WASHINGTON
UNION STATION
STATION EXPANSION

Draft Environmental Impact Statement for Washington
Union Station Expansion Project

**Appendix A3f – Final
Concept Development and
Evaluation Report Appendix F:
*Partner Comments on Concepts***

Partner Comments on Concepts

Exhibit A-1
Bus Terminal at Southeast

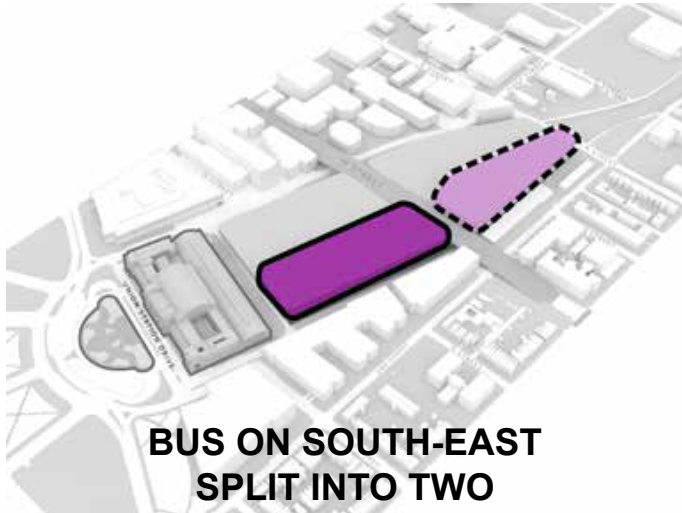
One option under consideration is to locate bus functions above the tracks, east of the existing garage in a north-south orientation (see Exhibit A-1: "Bus Terminal At Southeast"). This location is entirely inside of the property rights owned by Akridge. Applying our principle assessment criteria above, siting a bus facility in this location would effectively *eliminate* Burnham Place for the following reasons:

1. BP ground floor uses (at the H Street level or "podium level") are impossible to build. These include building lobbies, retail, and loading and parking entrances

2. Locating commercial or residential functions on top of buses *and* trains may not be marketable, and/or may not be acceptable from a security and threat vulnerability standpoint

3. Buses eliminate the ability to locate BP parking in a structural transfer truss below the H Street level
4. After accounting for one or two bus levels and a structural transfer truss above, the remaining available building height yields buildings of insufficient size to be marketable

5. There is no room adjacent to the bus facility to construct a road during Phase 2. Even if buildings could be built in this location, there would be no access to them

6. There is no ability to create any open spaces as part of Phase 2 south of H Street
7. Delivering sufficient building density and high-quality open spaces in this location during Phase 2 is a linchpin to the quality, character and vision of Burnham Place that are integral to its economic viability. These adverse effects in aggregate could create insurmountable obstacles to the commercial viability of developing the BP property north of H Street as well.

I.1. BP ground floor uses (at the H Street level or “podium level”) are impossible to build. These include building lobbies, retail, and loading and parking entrances. The SEP indicates the potential for limited BP ground floor use. It is clear that ground floor use is compromised, but it is not necessarily impossible. Lobbies, retail and service access could be incorporated to some extent into the perimeter of the bus facility.

Exhibit A-3
Bus Terminal at South

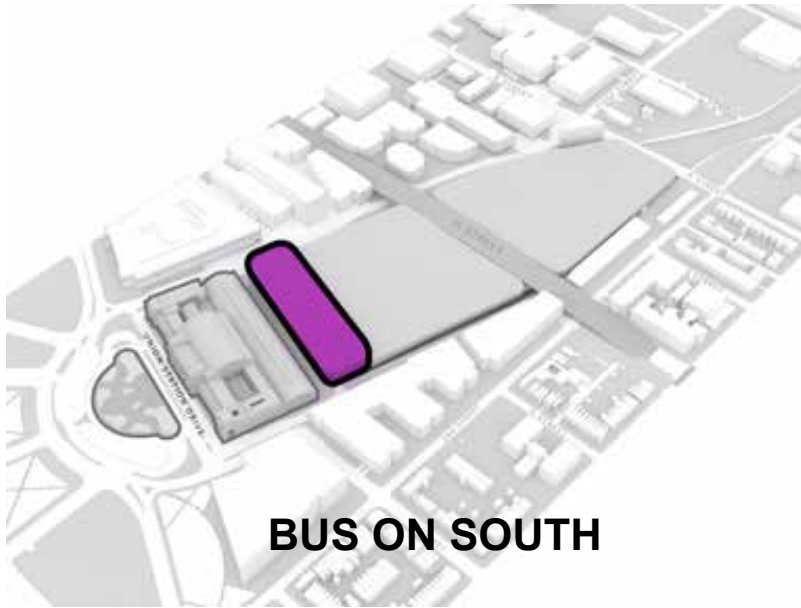
Workshop 9 included a bus facility oriented east-west, integrated above Concourse A with a Train Hall expanded north of the concourse, as shown in Exhibit A-3 “Bus Terminal at South.” This concept also includes an approximately 600-foot long, 40-foot tall bus ramp within the eastern edge of Burnham Place. The primary impacts to BP of this configuration include:

1. Removal of buildable area and potentially service road access in the southeast portion of the BP property
2. Visual impacts to buildings located at the eastern and southern edges of the BP property
3. Congestion within the BP property road network, depending upon the extent of bus passenger pick-up and drop-off activities

Some of these impacts may be substantially decreased by exploring bus facilities in this location, which have a smaller physical or visual footprint (as shown in Exhibit B-1). This

III.A. Buses on south – smaller facility
Based on the developing bus programming, a smaller facility would not meet the required bus capacity.

III.A.3. Congestion within the BP property road network, depending upon the extent of bus passenger pick-up and drop-off activities
There would be limited impact to the BP roadway network since the access ramp would be independent.

Exhibit A-4
Bus Terminal at North

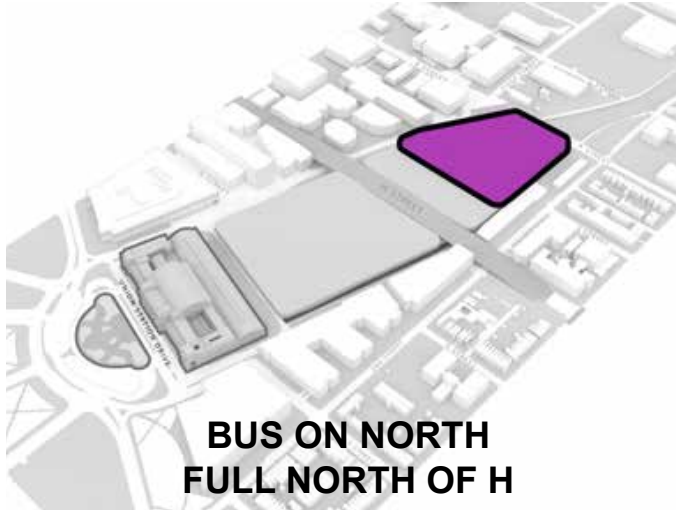
Workshop 9 also included options to locate buses throughout the entirety or a portion of BP's property north of H Street, as shown on Exhibit A-4: "Bus Terminal at North." For similar reasons we describe regarding the southeast bus option, we believe Project concepts which utilize nearly the entire amount of BP property north of H Street call into question the viability of the entire BP project. We suggest that concepts which limit bus facilities to areas within BP property north of Eye Street may have a less detrimental impact, as noted on Exhibit B-1. In addition, regarding various northern bus concepts explored to date, we have found:

- Commercial and residential uses do not appear viable atop bus facilities in this area
- Station or BP parking could be vertically compatible with bus facilities (at a considerably lower cost than building equivalent parking below tracks)
- Bus and parking facilities should be 'wrapped' and visually screened by other uses to the greatest extent possible to prevent negative visual impacts to BP and the surrounding neighborhoods

III.B. Buses north of Eye Street NE
The footprint of the proposed facility is around the south side of Eye Street. The ultimate N-S dimension will depend on the final bus program.

Exhibit B-1 Smaller Bus Facilities at Locations Currently Under Consideration

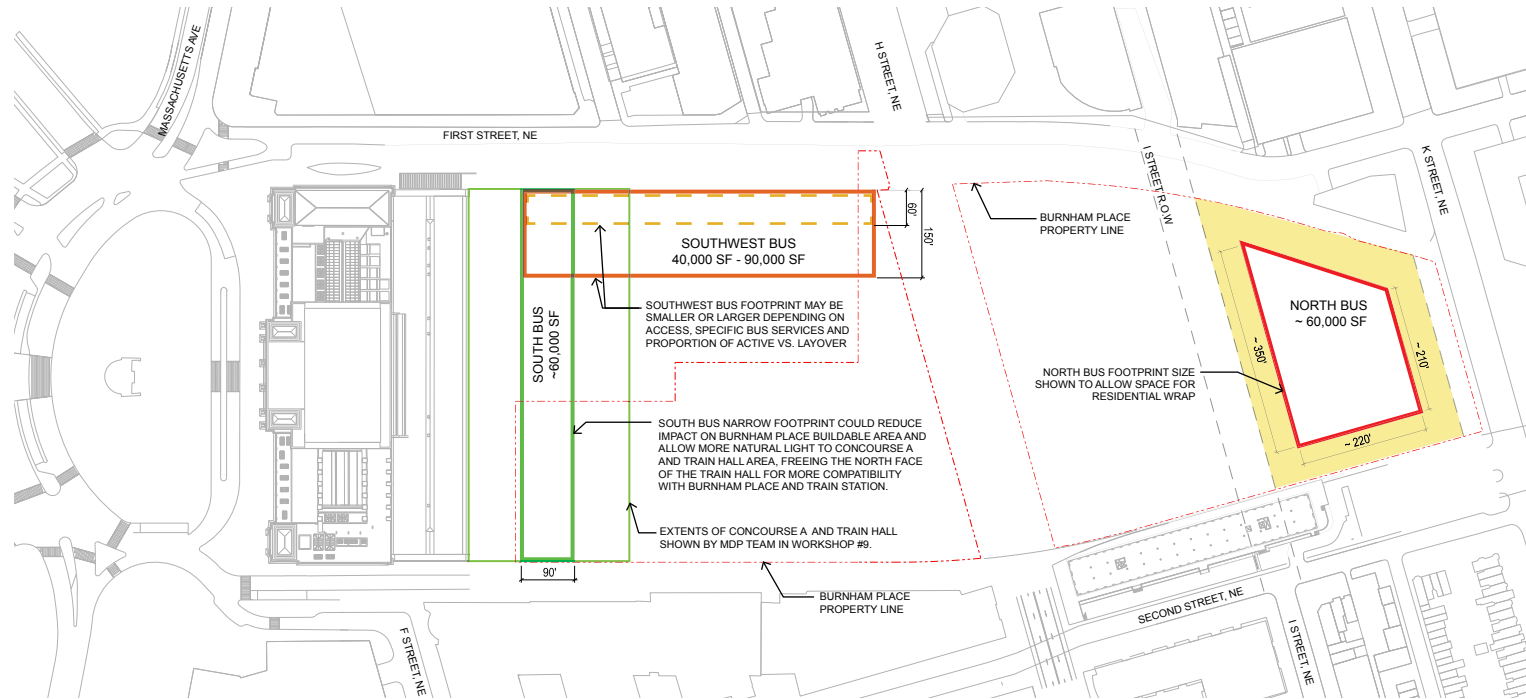
NOTE: DIMENSIONS INDICATED SHOW BUS FACILITIES WITH SMALLER FOOTPRINTS THAN THOSE CURRENTLY UNDER CONSIDERATION. THESE FACILITIES MAY HAVE LESS DETRIMENTAL IMPACT ON BURNHAM PLACE AND OTHER STATION FUNCTIONS.

PARKING BELOW, BUS ON SOUTH, E-W TRAIN HALL
 BY SEP TEAM FROM "STAKEHOLDER COORDINATION MEETING" - 05/24/2016

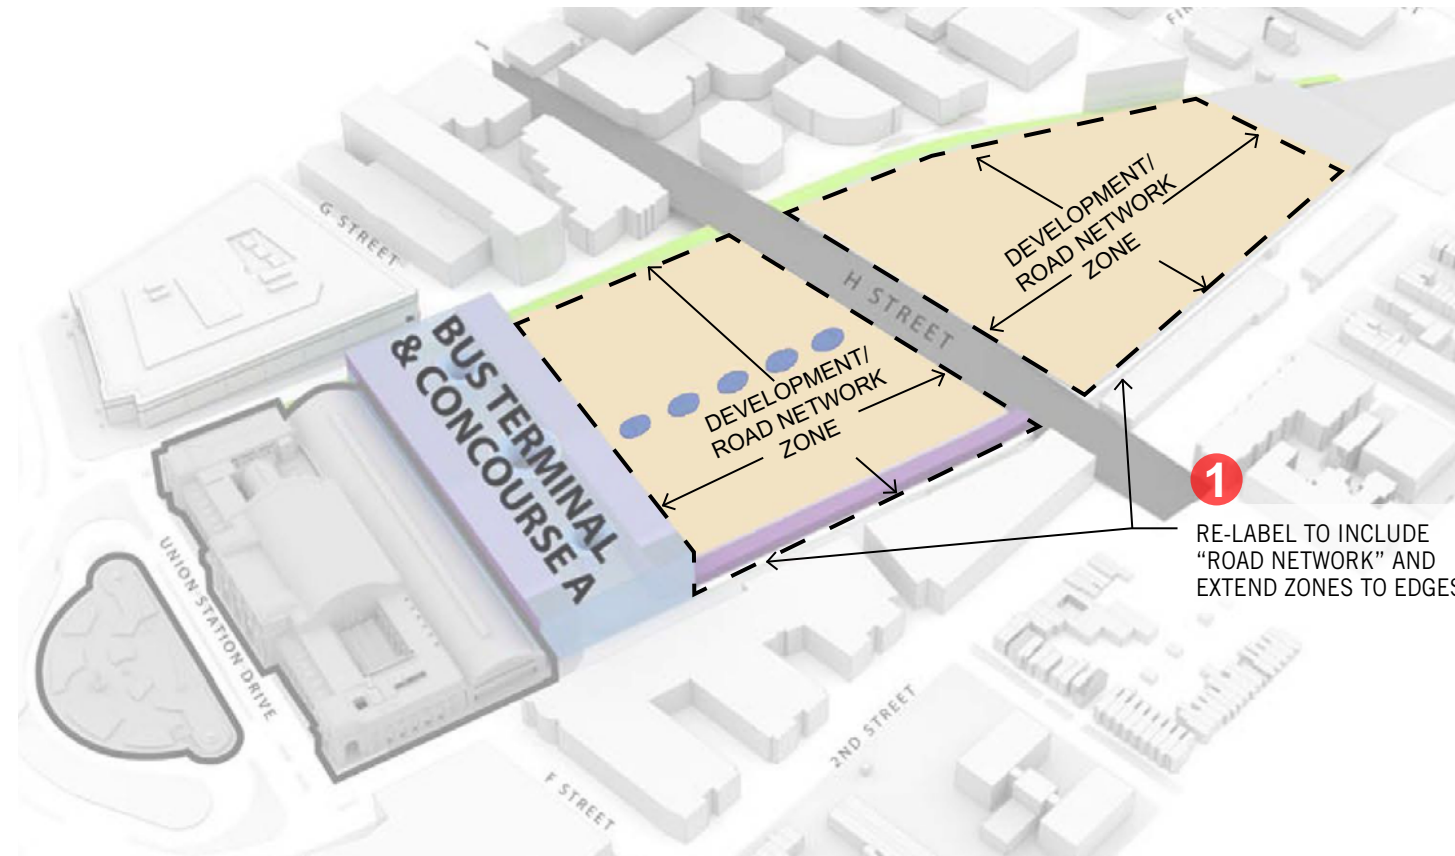
RE-LABEL TO INCLUDE
 "ROAD NETWORK" AND
 EXTEND ZONES TO EDGES

PARKING ABOVE, BUS ON NORTH, E-W TRAIN HALL
 BY SEP TEAM FROM "STAKEHOLDER COORDINATION MEETING" - 05/24/2016

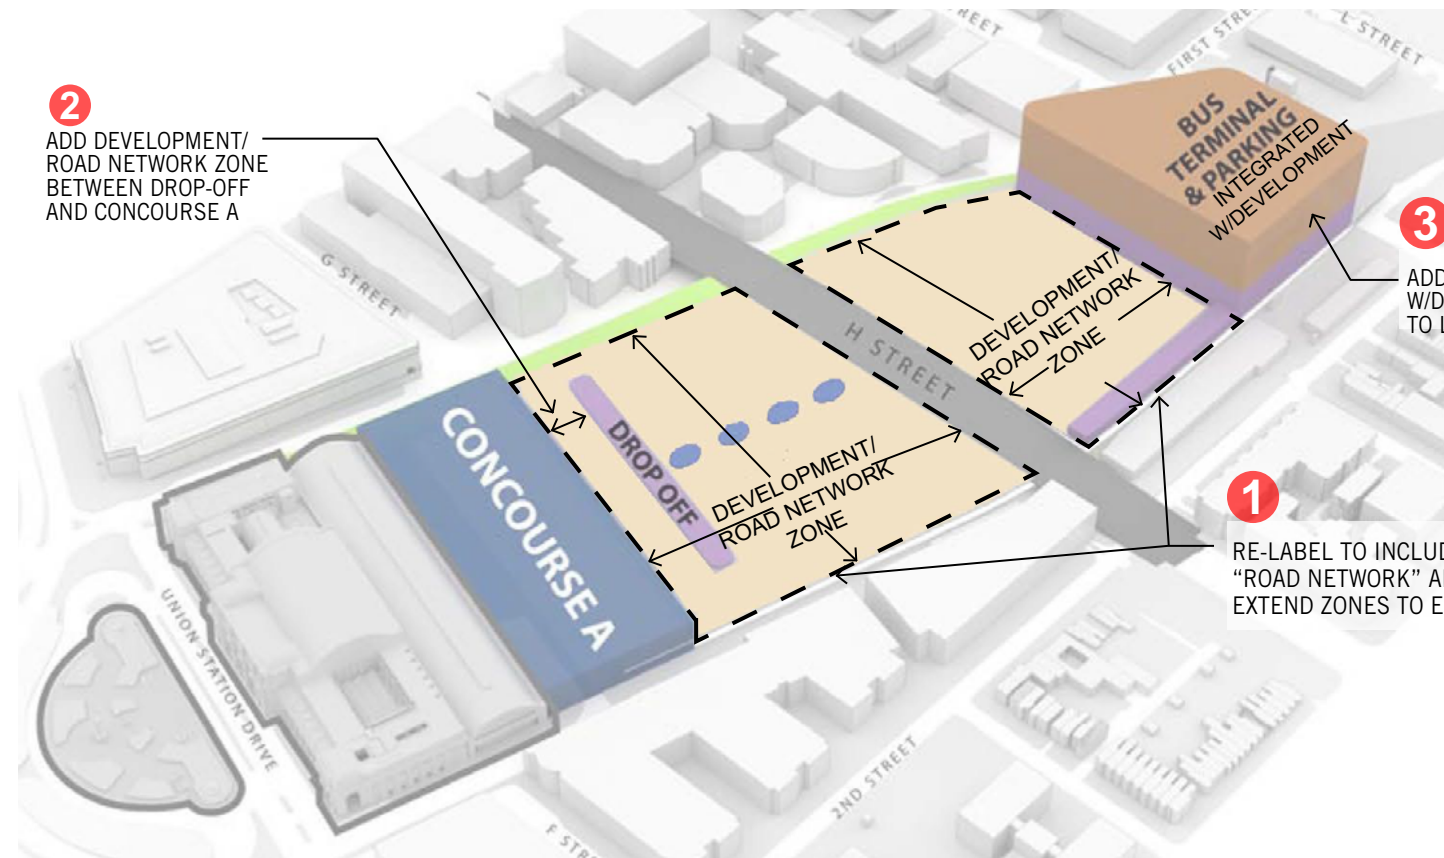
E. For “Bus on North” concepts with parking above, clarify that this above-podium garage could also be integrated with development

As shown, two concepts indicate a massive bus and parking garage with no development screening it. Labeling this garage to include integrated development can show the potential for buildings wrapped around or open spaces atop the garage—two critical features which greatly increase the feasibility of this concept from an architectural and place-making perspective.

PARKING BELOW, BUS ON NORTH, N-S TRAIN HALL
 BY SEP TEAM FROM "STAKEHOLDER COORDINATION MEETING" - 05/24/2016

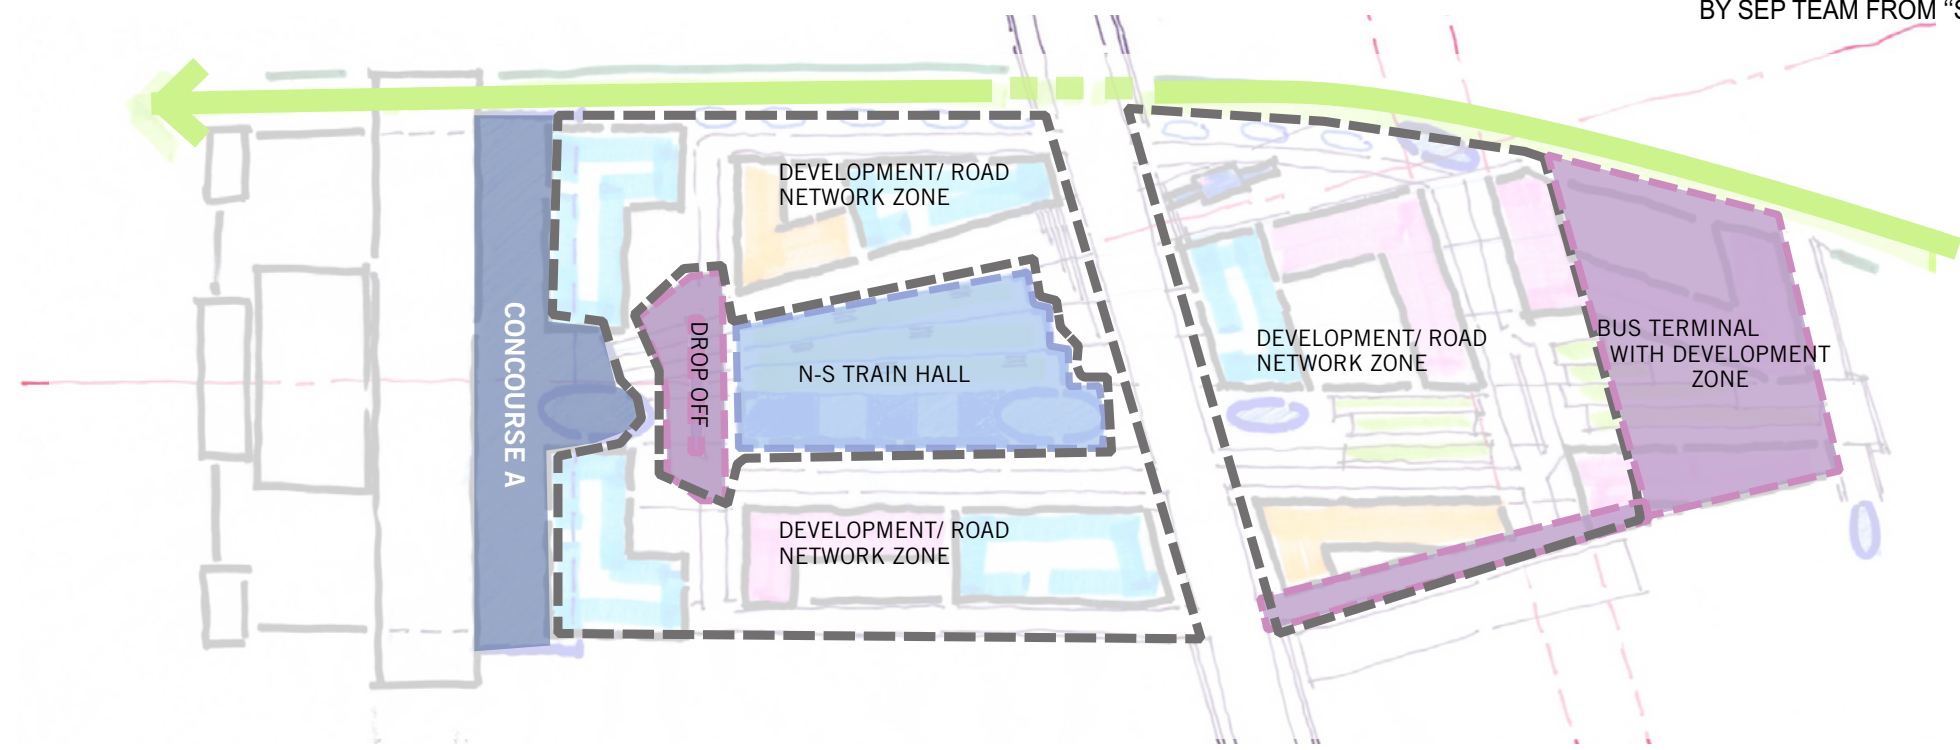
of both projects. However, the shape, location, and character of the north-south train hall shown in the concepts is detrimental to the SEP and Burnham Place. To provide sufficient open space, east-west pedestrian and vehicular circulation and development potential, a north-south train hall must have greater permeability, rather than serve as a visual and physical barrier. Previous studies by the SEP team explored north-south train halls with the following features: retail-programmed edges, substantial natural lighting, folded, elevated ground planes with clerestory day-lighting to below, and areas for pedestrians and vehicles to traverse across.

While the specific nature and character of a train hall will be determined later during the concept and alternative refinement process, initial concept images will determine public perception of the proposed character of a train hall. We recommend rather than show a repetitive, extremely long, unbroken, all-glass structure, more flexible imagery or icons be incorporated which could allow for the combination of uses described above.

I.5) The North-South Train Hall as shown prevents sufficient opportunity for placemaking
The Train Hall design illustrated in the report does not indicate the actual geometry and configuration of train hall. Further, Appendix B: Supporting Urban Design and Open Space outlines the various opportunities for meaningful placemaking, one of which is an indoor grand civic space that occupies a large proportion of the site. Train hall design will be further developed in the next phase of design.
